Bethesda Downtown Design Advisory Panel

Meeting Minutes

PROJECT: Avondale, 320200050

DATE: July 22, 2020

PROPOSED CONDITION
SITE DISTANCE
EVALUATION EXHIBIT

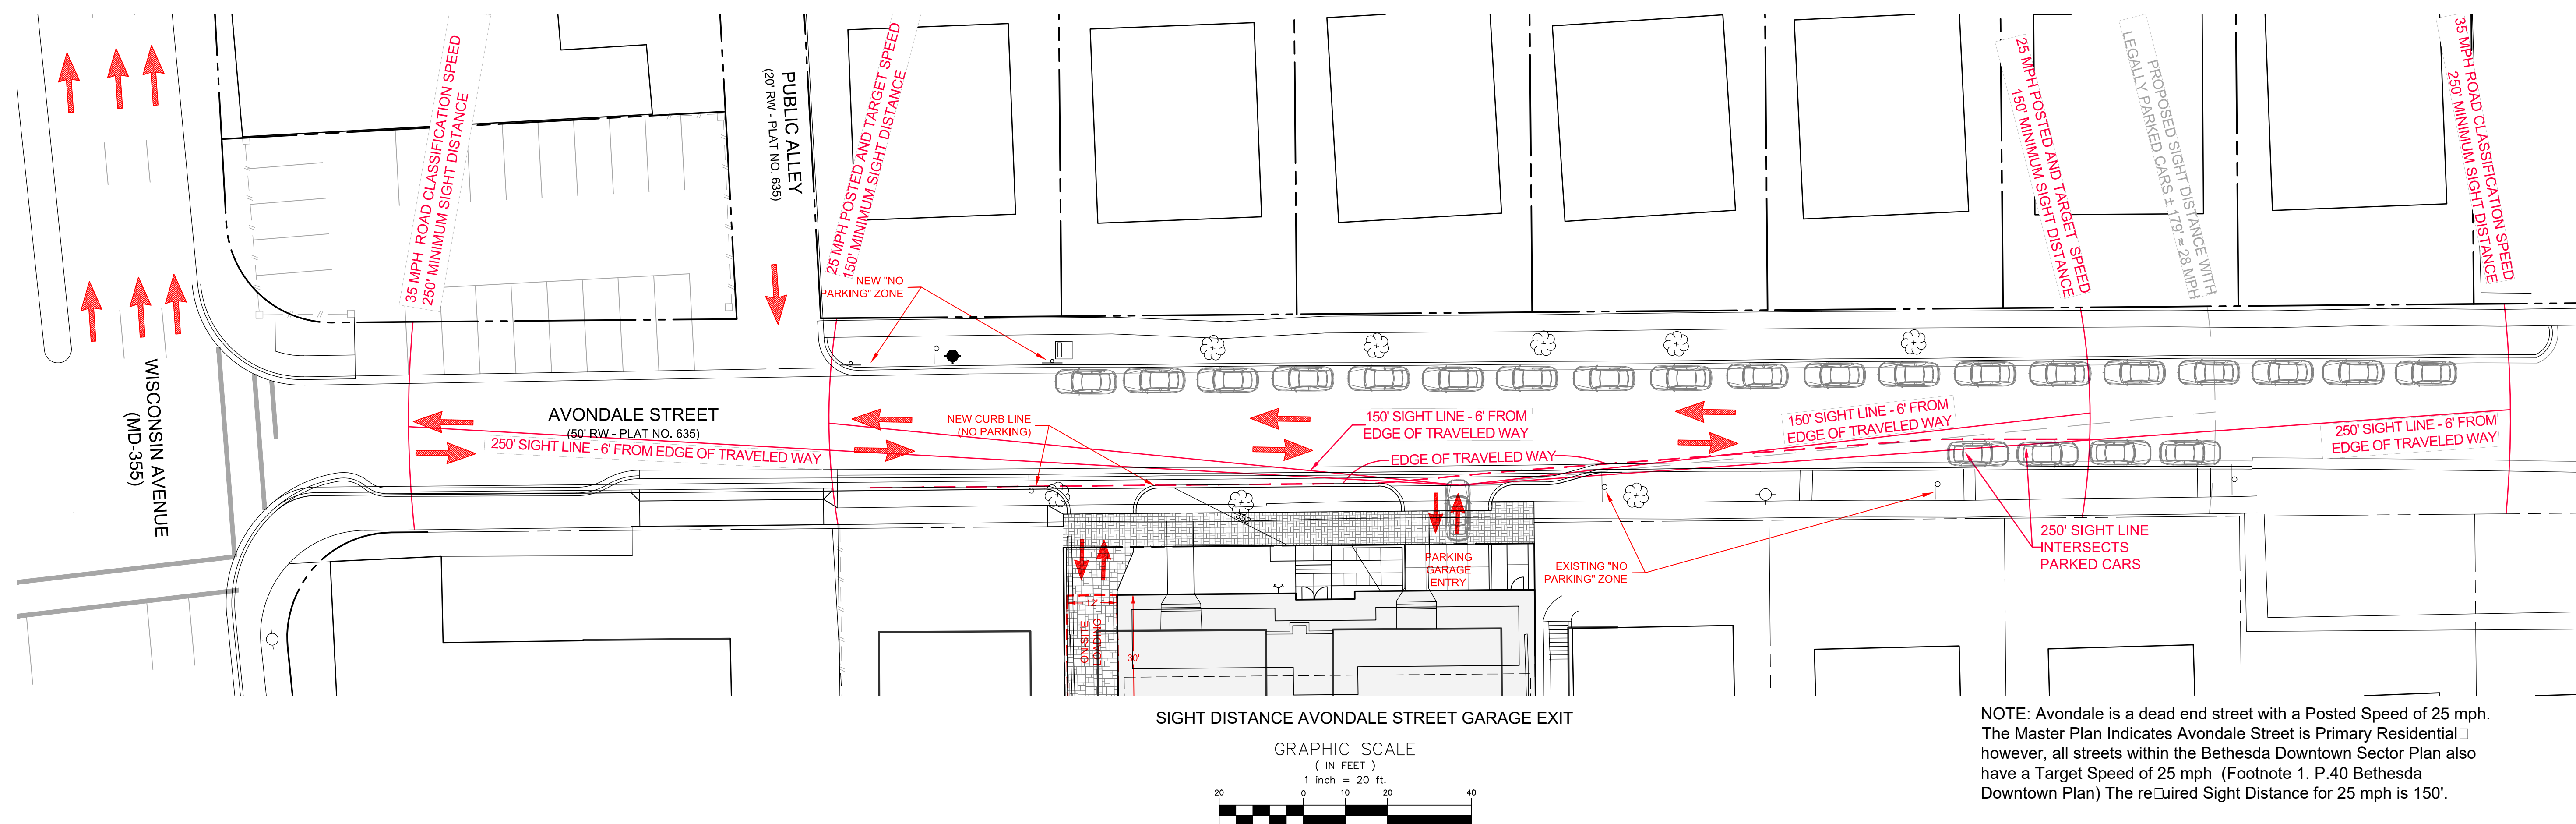
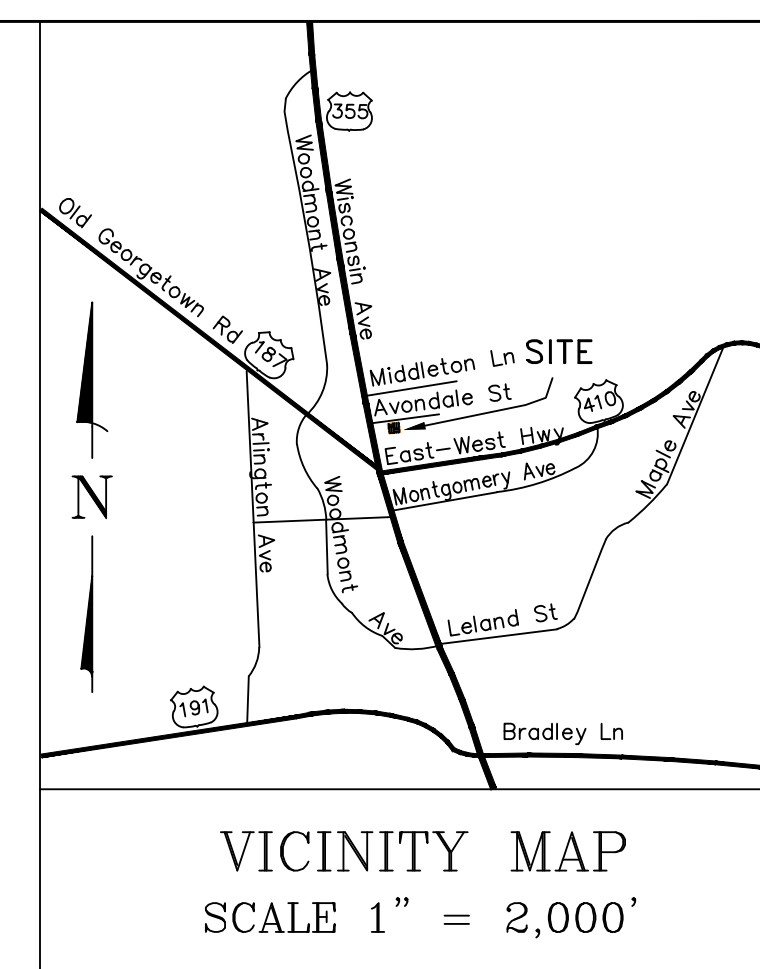
3. **Sight Distance:** A Copy of the accepted Sight Distance Evaluation certification is enclosed for your information and reference.
 - a. **Garage Entrance:** Avondale Street is classified as a Primary Residential Street and the sight distance is approved per the following reason(s):

- i. The sight distance looking left meets the minimum requirements per the road classification with no parking along frontage of the property as proposed by the applicant.

- ii. The sight distance looking right does not meet the requirements per the road classification due to the existing cars parked (permit parking) along the street. We agree on the sight distance of 150-ft to the right based on the following reasons:

- The posted speed on Avondale Street is 25 mph and the sight distance complies to posted speed requirements.
 - Avondale Street is a dead-end street to the right of the proposed driveway with existing permit parking along both sides of the street which acts as traffic calming measure.

- Existing "No Parking" to the right of the proposed driveway as shown in the plan will remain in place.
 - b. **Loading Space:** The sight distance meets the minimum requirements per the road classification and is approved per the following reason(s):

- i. Existing street parking west of loading space to be removed per DPS Fire and Rescue requirements as shown in the plan.
 - c. No parking along frontage of the property as proposed by the applicant. The line of sight for the proposed driveways should not be blocked by any proposed obstructions such as proposed trees, street light poles or traffic signs. At the permit stage, the applicant should work with DPS to make the necessary modifications to the locations of the items mentioned in order to meet the sight distance requirements for the proposed driveways.

FIRE DEPARTMENT
ACCESS PLAN

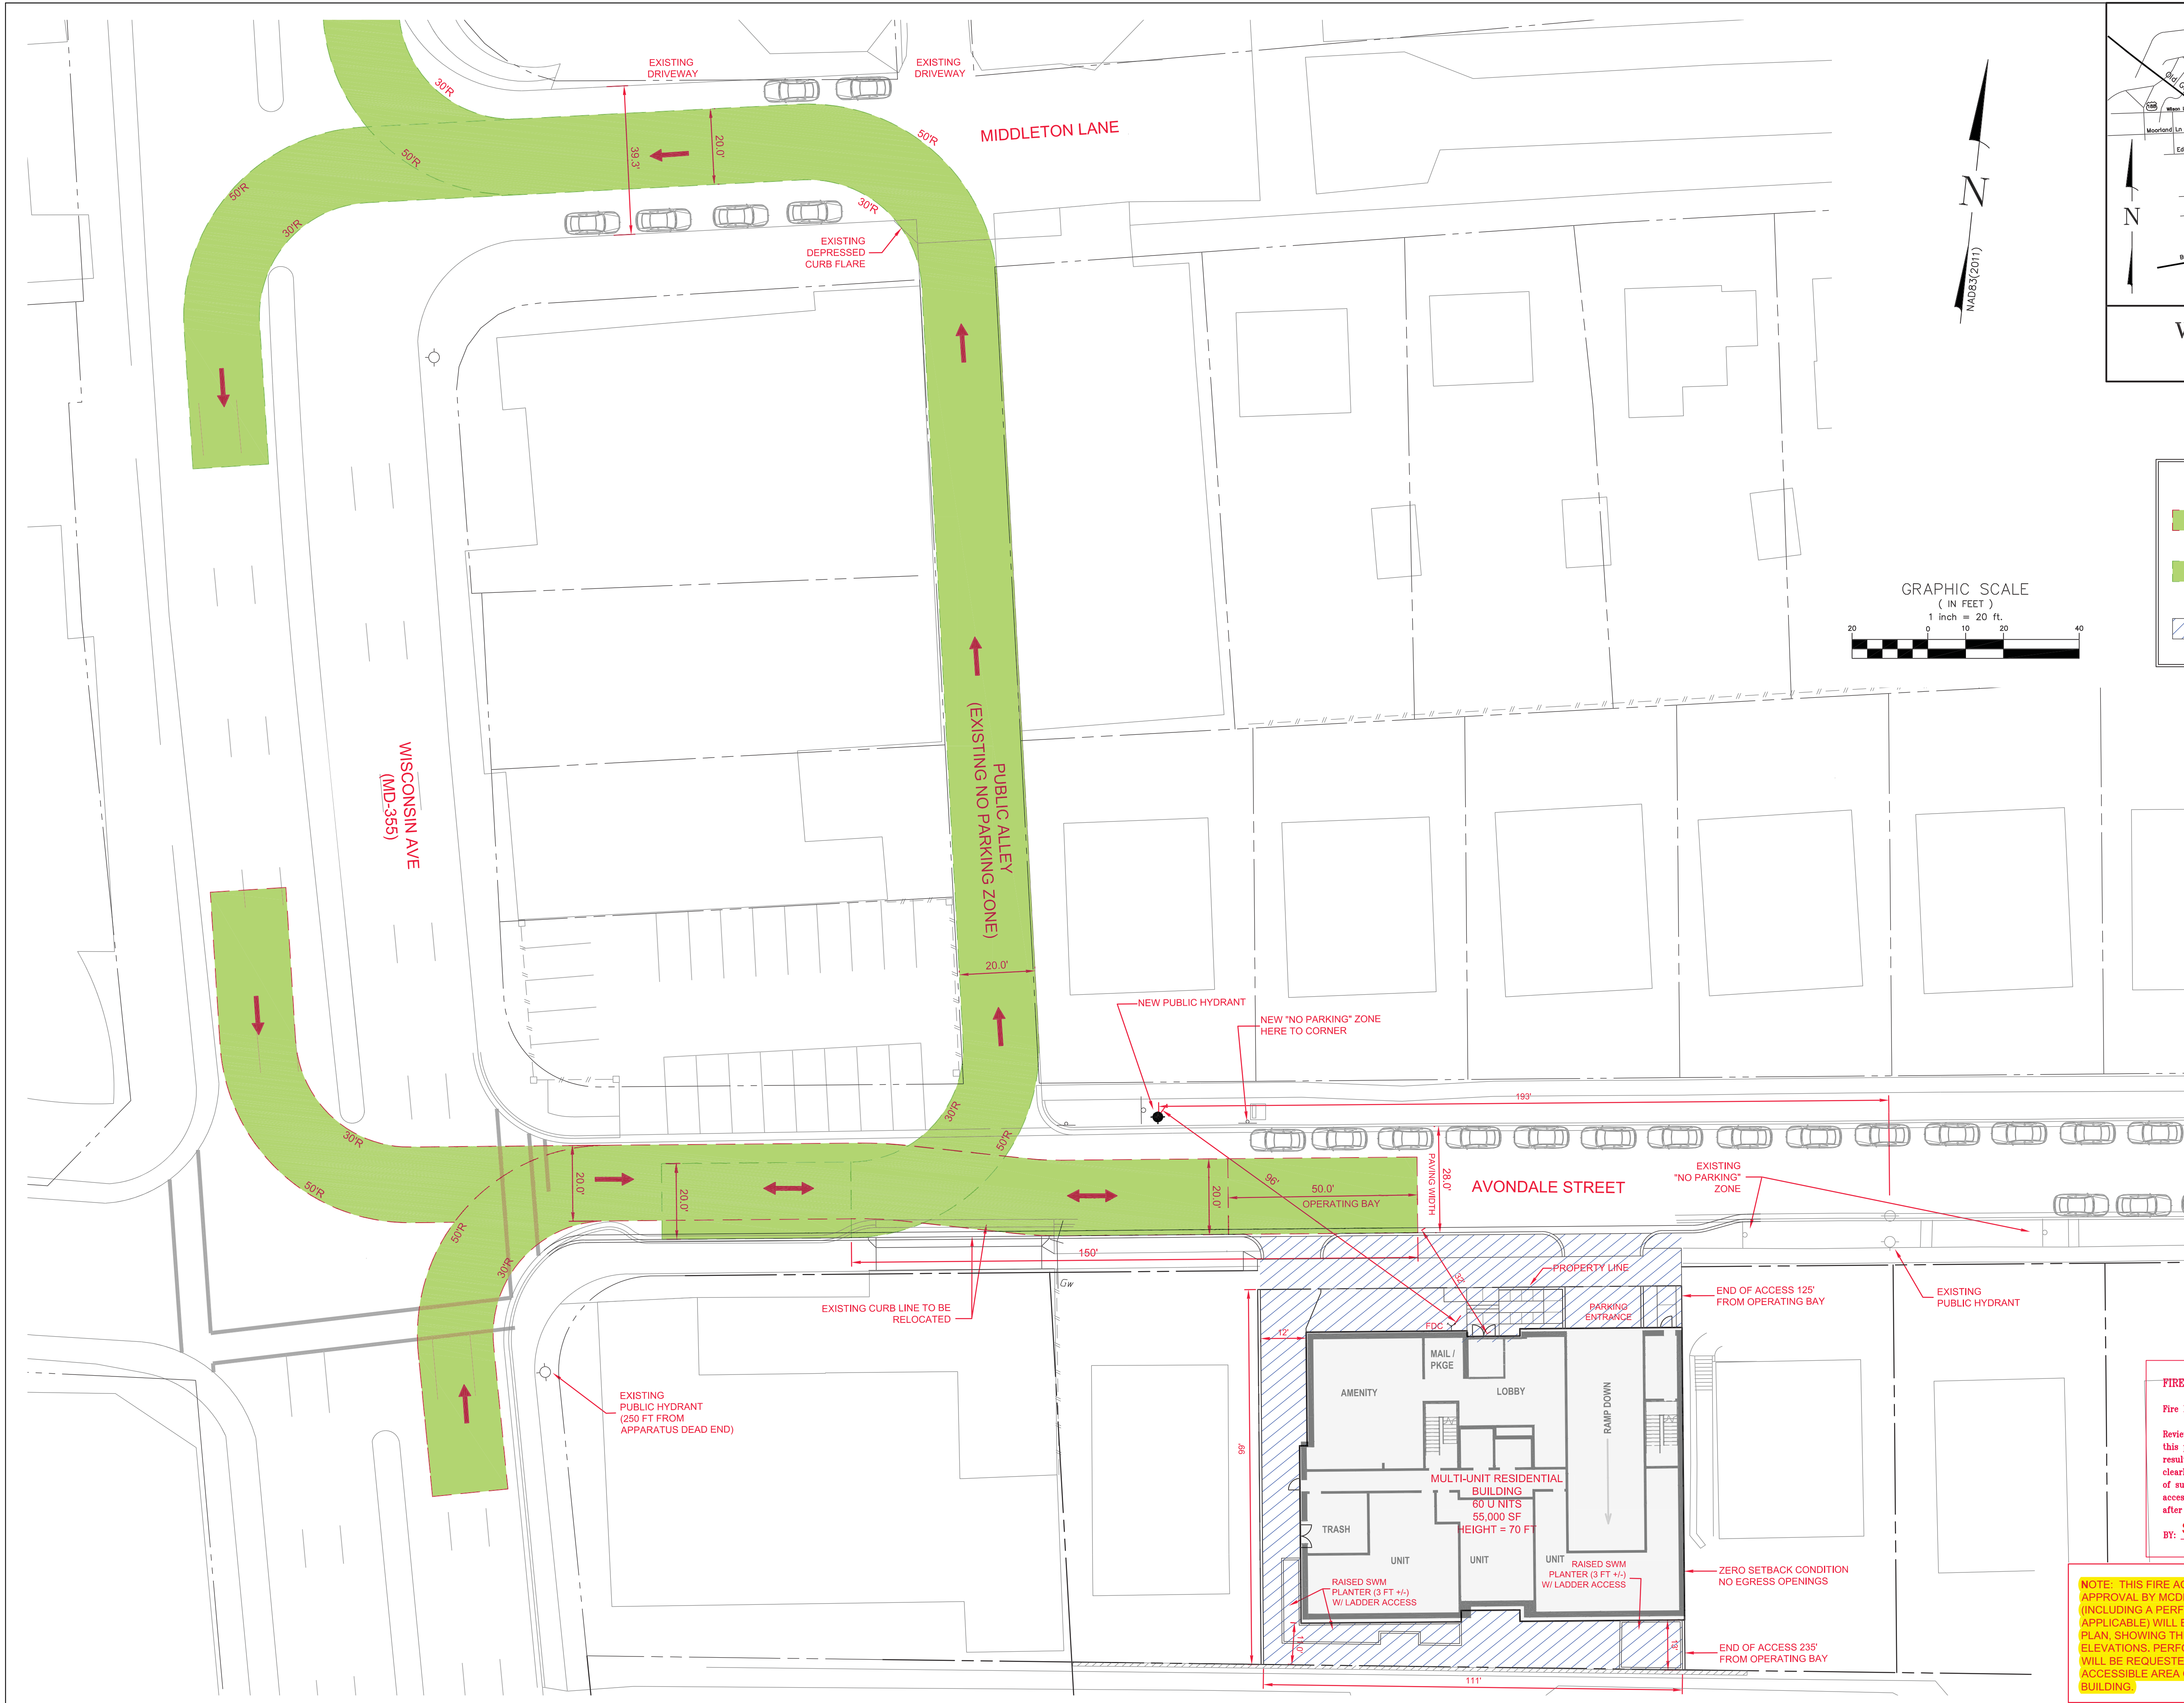
NOTE: THIS FIRE ACCESS PLAN IS PRELIMINARY. A FINAL APPROVAL BY MCDPS FIRE ACCESS & WATER SUPPLY (INCLUDING A PERFORMANCE BASED DESIGN MEMO IF APPLICABLE) WILL BE REQUIRED AT THE TIME OF SITE PLAN, SHOWING THE PROPOSED BUILDING FLOOR PLANS & ELEVATIONS. PERFORMANCE BASED DESIGN APPROVAL WILL BE REQUESTED FOR LESS THAN 15 FEET OF CLEAR ACCESSIBLE AREA ON THE WEST & SOUTH SIDES OF THE BUILDING.
